## **AMENDMENTS TO THE DRAWINGS**

**Applicant submits replacement third and fourth sheets of drawings (original Figs. 5 and 6) corrected as follows:**

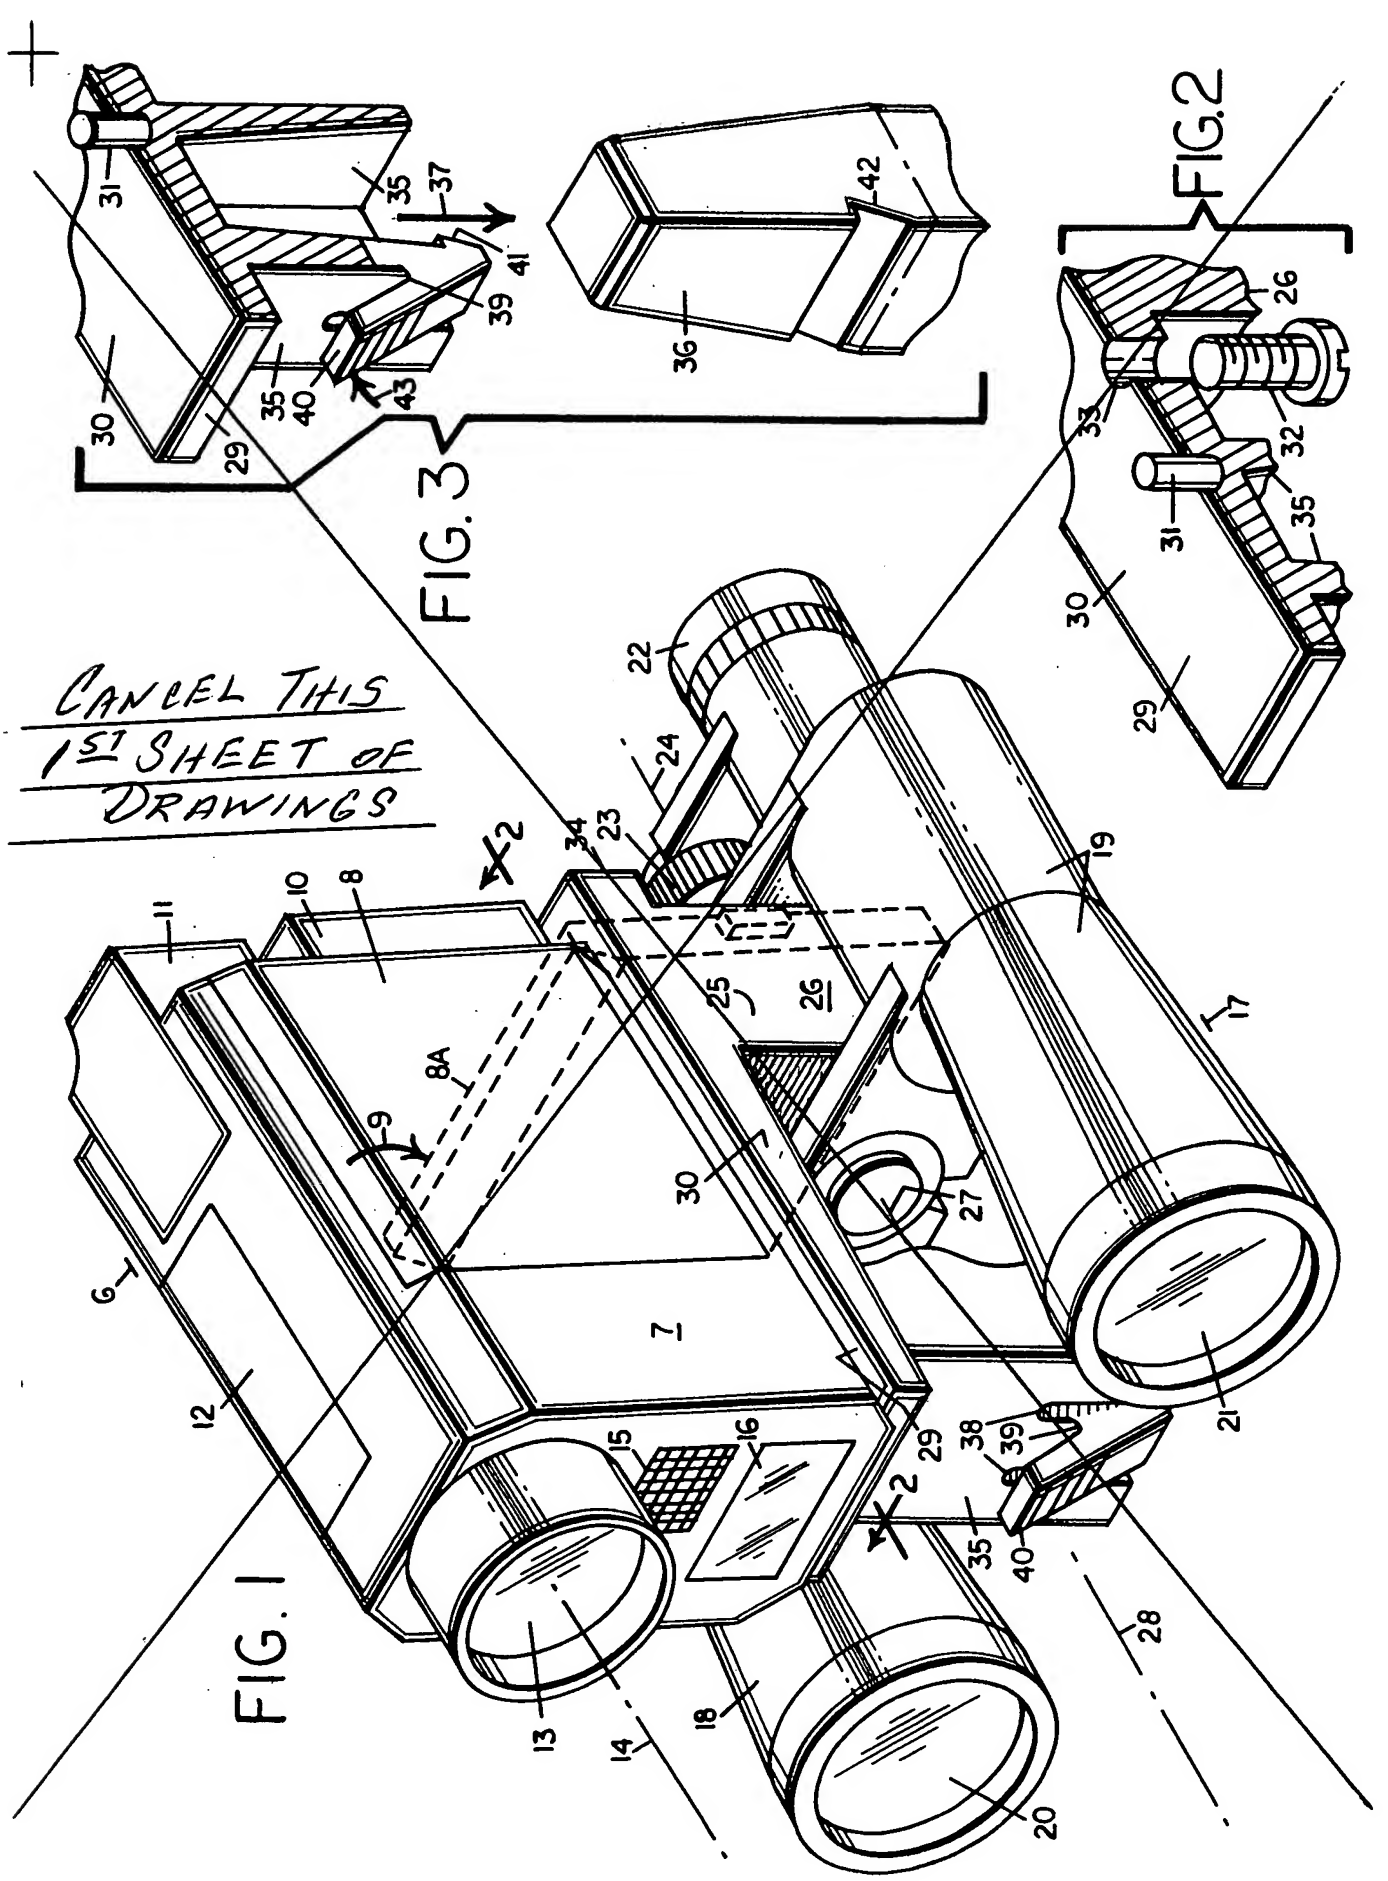
**"Fig. 5" (as originally filed) has been changed to "Fig. 1".**

**"Fig. 6" (as originally filed) has been changed to "Fig. 2".**

**(a) The original placement of the numeral "44", which appears in both drawings is intended to refer to the "housing" generally . That fact is stated in the specification as originally filed. But the original placement of the numeral "44" is misleading; one must read the specification very carefully in order to understand that the numeral "44" is identifying the housing generally and is not referring to a specific portion of the housing. In the corrected Replacement Sheets, the numeral "44" has been moved to a "stand-alone" location with a "T-shaped" leader that makes it immediately obvious that it is referring to the housing generally.**

**(b) Figure 5 as originally filed, contains the numeral "44A" which identifies a specific portion of the housing from which a square tube "35" depends for mounting on a tripod (all as described in the specification as originally filed). The square tube "35" is not an essential part of the invention as currently claimed, so there no longer is any need to refer to that specific portion ("44A") of the housing to which the square tube "35" is affixed. Accordingly, in the corrected Fig. 5 (now Fig. 1), the numeral "44A" has been deleted. In order to avoid major alteration of the drawings, as would be**

FIG. 4

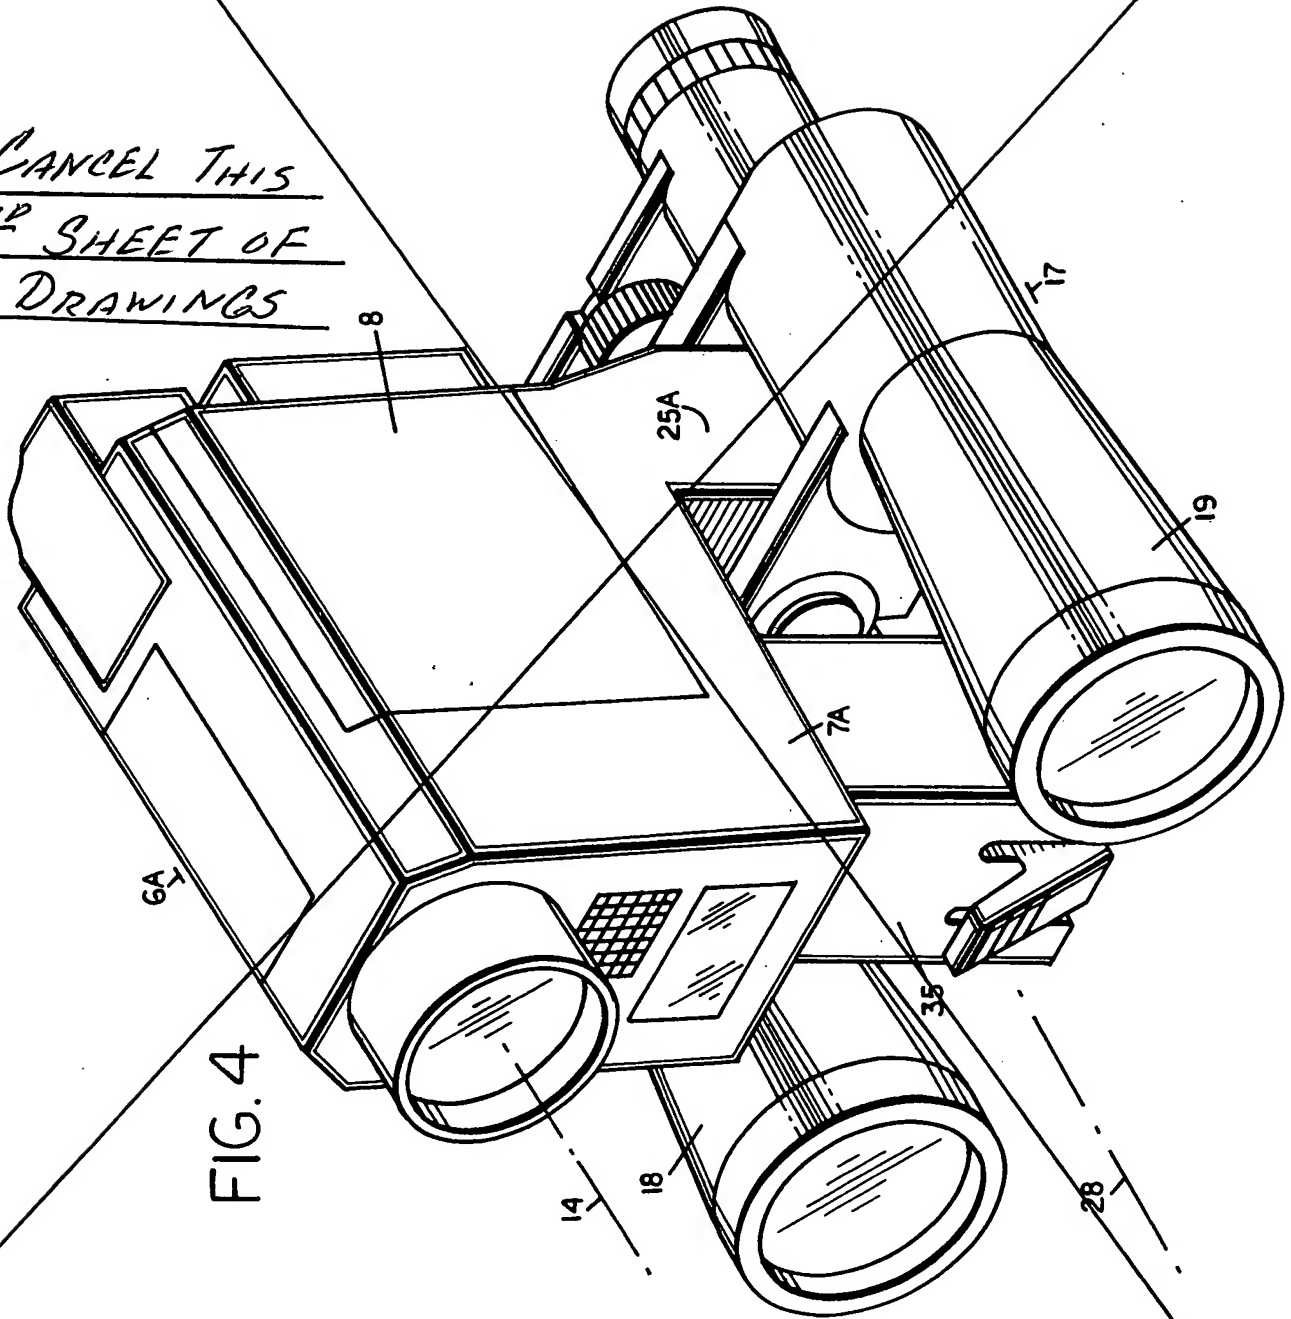
CANCEL THIS  
2<sup>ND</sup> SHEET OF  
DRAWINGS
